KAWEAH LEMON COMPANY

Re: Comments on Draft Environmental Impact Report –
Southern California Edison's San Joaquin Valley Cross Valley Loop
200KV Transmission Line Project
CPUC A.08/05-039, SCH # 2008081090

OPENING TESTIMONY OF PACE
(PROTECT AGRICULTURE COMMUNITIES ENVIRONMENT)

Figure 1. Alternative 3A Reroute to Bypass the Stone Corral Ecological Reserve

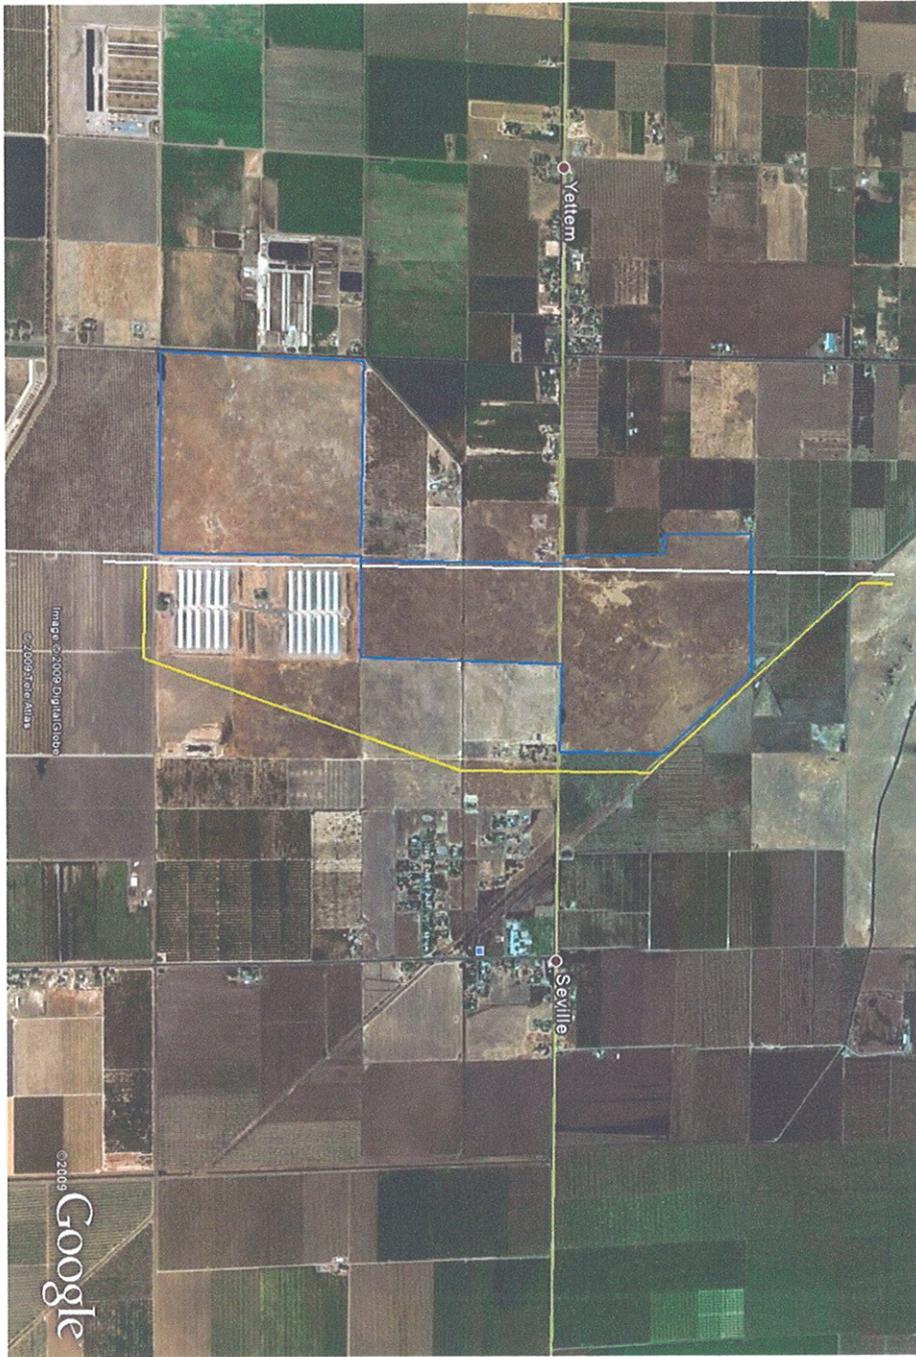
Figure 4.4-4 in Section 4 of the draft Environmental Impact Report shows the location of the Stone Corral Ecological Reserve and generally defines designated critical habitat in the vicinity. The proposed Alternative 3A reroute path is shown in Figure 1. Figure 2 shows a closer view of the Stone Corral Ecological Reserve and surrounding area with the ecological reserve area outlined in blue, the existing Big Creek – Rector 220 kV transmission lines path across the ecological reserve marked in white, and the proposed preliminary Alternative 3A reroute path around the ecological reserve marked in yellow.

For the preliminary Alternative 3A reroute, the new double circuit 220 kV San Joaquin cross valley loop transmission line leaves the existing Big Creek – Rector 220 kV transmission lines right of way South of Avenue 376 approximately 11.6 miles north of the Rector Substation. First, the line proceeds easterly approximately 1200 feet through existing newly planted orchard. Second, the line proceeds northeasterly approximately 4400 feet through previously cultivated fields, which apparently are private property, to a point about 50 feet east of Road 152 and about 1250 feet South of Avenue 384. Third, the line proceeds north approximately 2400 feet through a previously cultivated field, which apparently is private property, across Avenue 384 and through an orchard to an abandoned railroad right of way. Fourth, the line proceeds northwesterly approximately 4100 feet along the abandoned railroad right of way to a point about 50 feet east of the existing Big Creek – Rector 220 kV transmission lines and north of the ecological reserve. Fifth, the line then proceeds north adjacent to the existing Big Creek – Rector 220 kV transmission lines to the point of intersection approximately 14.6 miles north of the Rector Substation, where the new line proceeds easterly and crosses Stokes Mountain as before.

Figure 4. Alternative 3 Road Story, Page 19, with Reroute Marked in Red

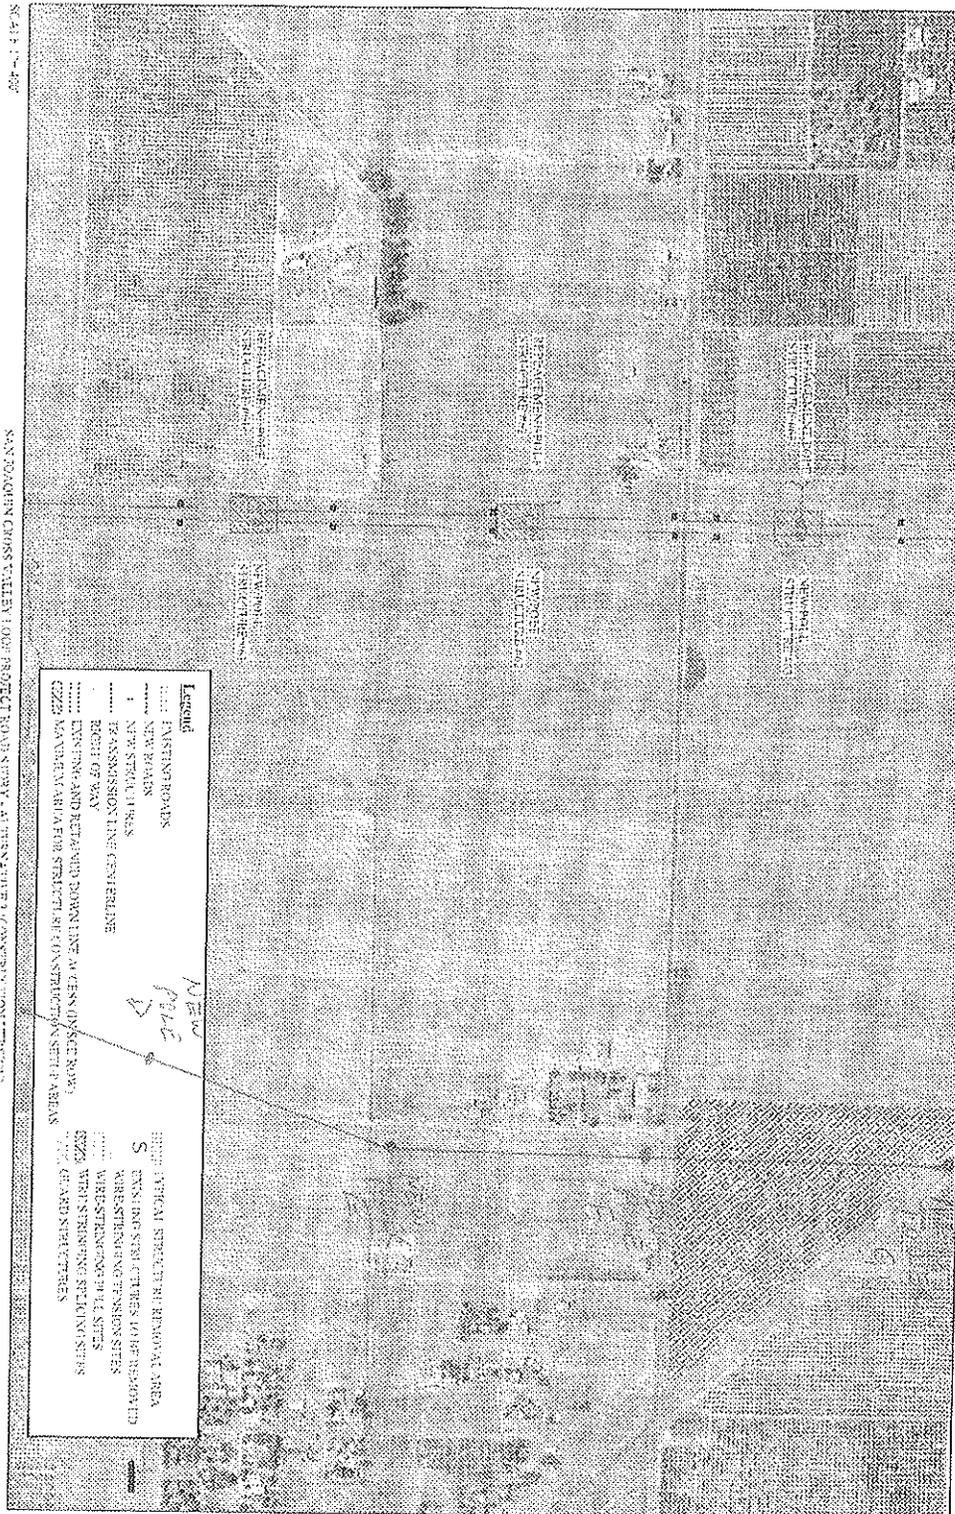
Figures 3 and 4 show the Alternative 3A cross valley loop reroute preliminary tower spotting from new tower structure A to the next point of intersection, tower structure E located East of Road 152 and South of Avenue 384, using three tangent pole structures, B, C, and D.

Figure 4 also shows the Alternative 3A cross valley loop reroute preliminary tower spotting from new tower structure E to the next point of intersection, tower structure G located on the abandoned railroad right of way and north of Avenue 384, using one tangent pole structure, F.

Figures 3 through 7 also show that 24 Alternative 3 structures, replacement structures #59 through #74 and new structures #59 through #66, will not be needed if the proposed preliminary Alternative 3A reroute is employed. These changes are marked in green.
